UNITED STATES PATENT AND TRADEMARK OFFICE

10/713,548

Office Action Summary	Application No. 10/713,548	Applicant(s) CHEN ET AL.	
	Examiner Ricky L. Mack	Art Unit 2873

DETAILED ACTION

FIG. 3

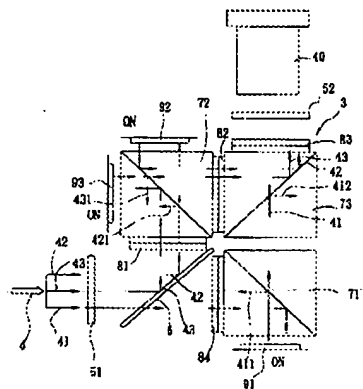
Chuang discloses, as in claims 1, 8, 10, 12, 17, 19 and 20, a color management architecture comprising for managing red, blue, and green primary colors from a substantially white input light (4), the architecture comprising: an input dichroic beam splitting element (6) configured to split the input light into a first portion and a second portion (see fig. 3), wherein the first portion contains a first substantially non-green primary color from the input light and wherein the second portion contains a second substantially non-green primary color from the input light and a substantially green primary color from the input light; a first polarizing beam splitter (71) configured to receive the first portion light containing the first substantially non-green primary color from the input dichroic beam splitting element (6); a first reflective panel (91) adjacent to the first polarizing beam splitter (6) and configured to modulate and reflect the first portion light; a second polarizing beam splitter (72) configured to receive the second portion light and to split the second portion light into a third portion light containing

the second substantially non-green primary color and a fourth portion light containing the substantially green primary color; a second reflective panel (93) adjacent to the second polarizing beam splitter (72) and configured to modulate and reflect the third portion light; a third reflective (92) panel adjacent to the second polarizing beam splitter (72) and configured to modulate and reflect the fourth portion light; and a third polarizing beam splitter (73) adjacent to the first and second polarizing beam splitters and configured to combine the modulated and reflected lights of the first, third, and fourth portions to form an output light (whole document relevant). Chuang discloses a device sufficient in structure to anticipate the limitations cited in claims 1-20. While Chuang does not specifically mention the non-green and green color limitations, applicant does not provide a specific structural limitation, which Chuang does not disclose. Chuang's device provides a broad teaching which is considered to include the specific function, which the present invention claims.

Chuang discloses, as in claim 2, a polarization element (84) between the input dichroic beamsplitter and the 1st polarization beam splitter.

Chuang discloses, as in claim 3, a polarization element (81) between the input dichroic beamsplitter and the 2nd polarization beam splitter.

Chuang discloses, as in claim 4, a polarization element (84) between the input dichroic beamsplitter and the 1st polarization beam splitter, and a polarization element (81) between the input dichroic beamsplitter and the 2nd polarization beam splitter.
